INNER WEST COUNCIL

DEVELOPMENT ASSESSMENT REPORT

Application No.	D/2018/584
Address	59 Lilyfield Road, ROZELLE NSW 2039
Proposal	Demolition of existing rear building on the site, adaptive reuse of existing building at the front of the site on the corner of Lilyfield Road and Burt Street and additions and alterations to that building to provide a residential flat building comprising six (6) dwellings, and associated works, including parking, landscaping and communal open space.
Date of Lodgement	5 November 2018
Applicant	Ranon Property
Owner	Ms C J Cavers and Mr R W Gazzard
Number of Submissions	Objections from 2 properties
Value of works	\$1,100,000
Reason for determination at Planning Panel	Clause 4.6 variation to FSR, Site Coverage and Landscaped Area exceeds officer's delegation/ SEPP 65 affected development
Main Issues	Impact to Desired Future Character of Easton Park Distinctive Neighbourhood/Heritage Conservation Area, Inadequate communal open space, safety issues to ground floor private open space, insufficient motorcycle and bicycle parking, impact to public drainage facility, Breach of FSR, Site coverage and Landscape Area development standards.

E03 Proposed South Elevation - Lilyfield Rd
 1:100

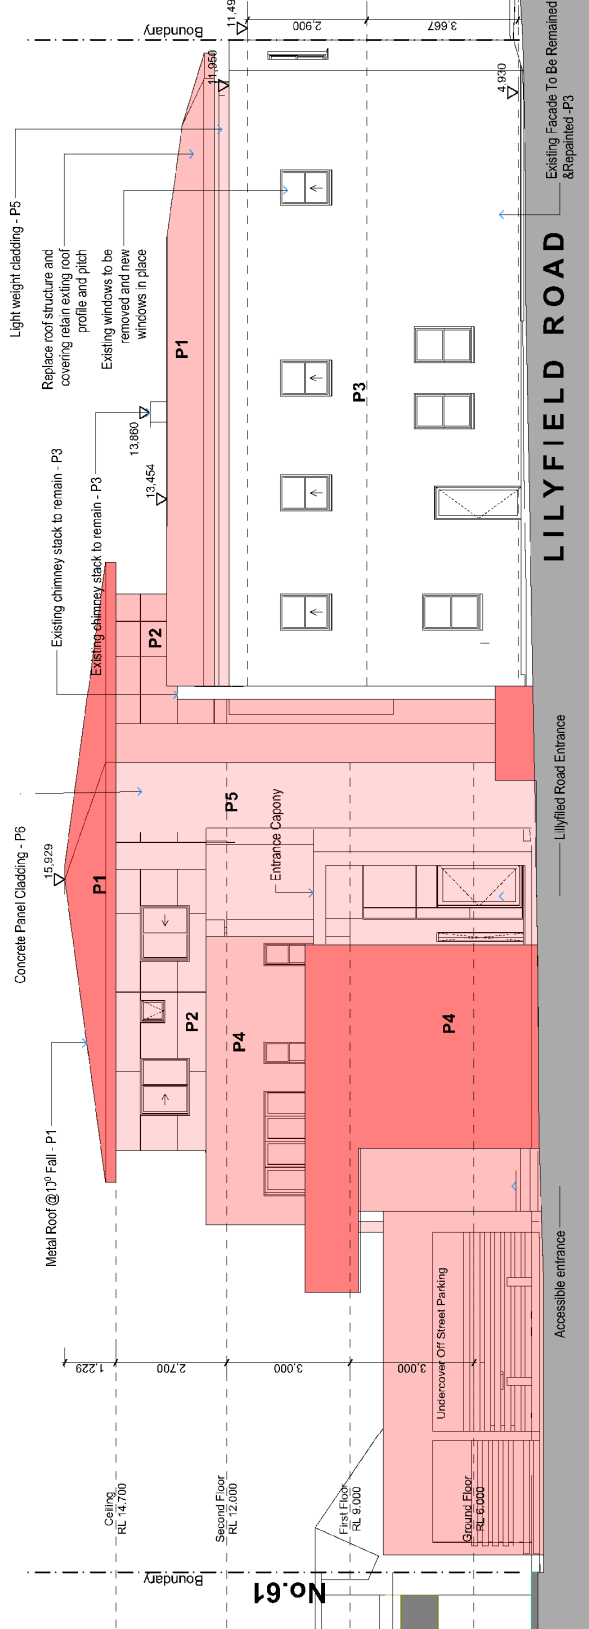
Window openings and proportions of the corner building do not match with the existing, e.g. window at the western end of the northern elevation is shown as the same size as the adjacent window, which it is not and shows the door on the ground floor as a window. Existing door and window openings are to be retained. A Demolition plan and the drawings

need to be amended to correctly show the existing openings and annotated appropriately to indicate proposed changes to existing openings and new openings.

Demolition Plan
1:200

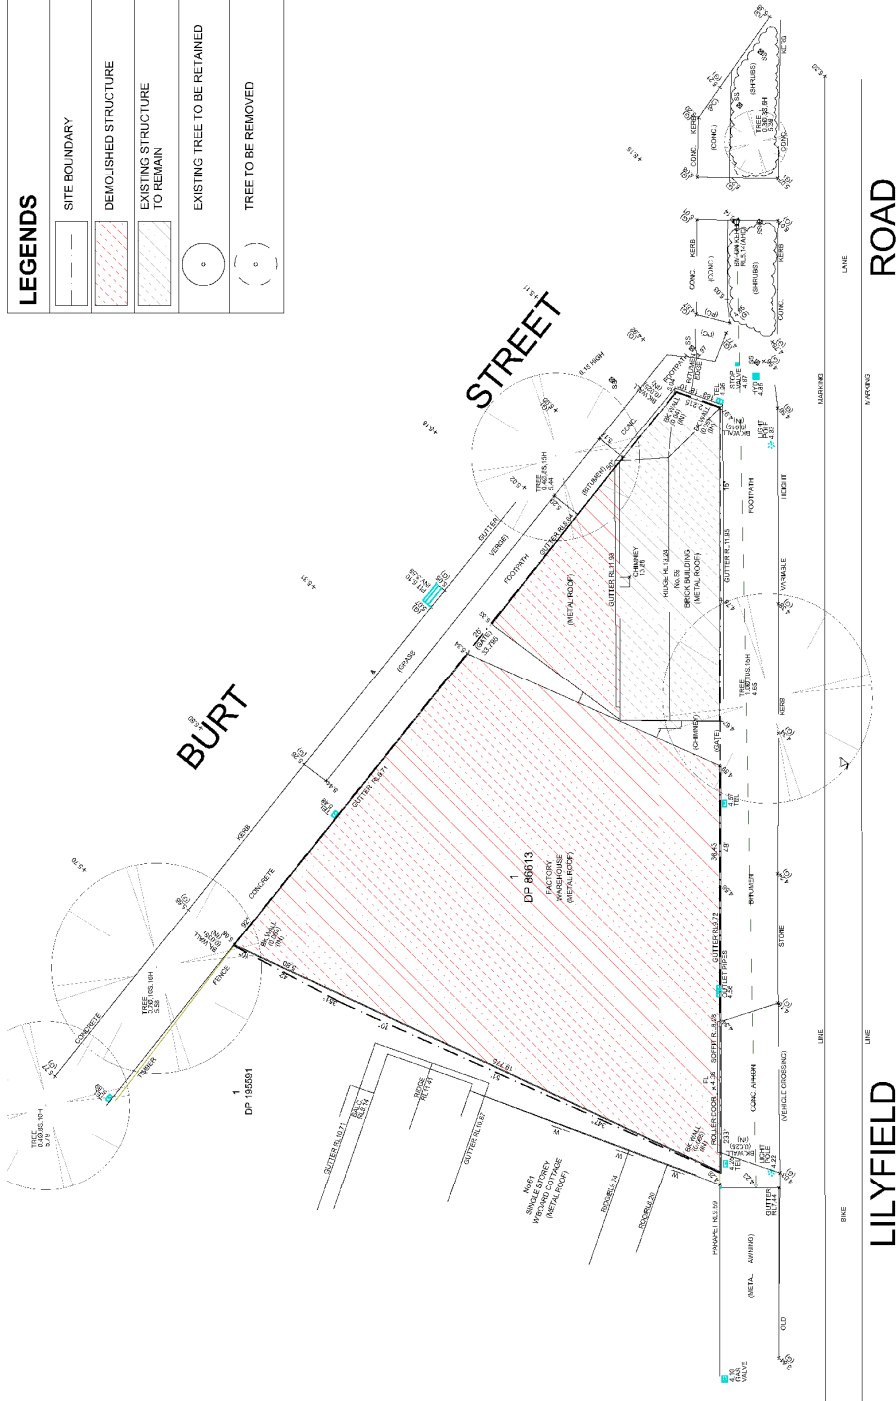
The demolition plan indicates demolition of the factory building to the rear of the site and the metal roof to the north of the corner building. The plans do not illustrate the extent of the proposed demolition within the corner building. The applicant is required to carry out a

The architectural drawings need to be annotated to show building fabric proposed to be retained, demolished or reinstated.
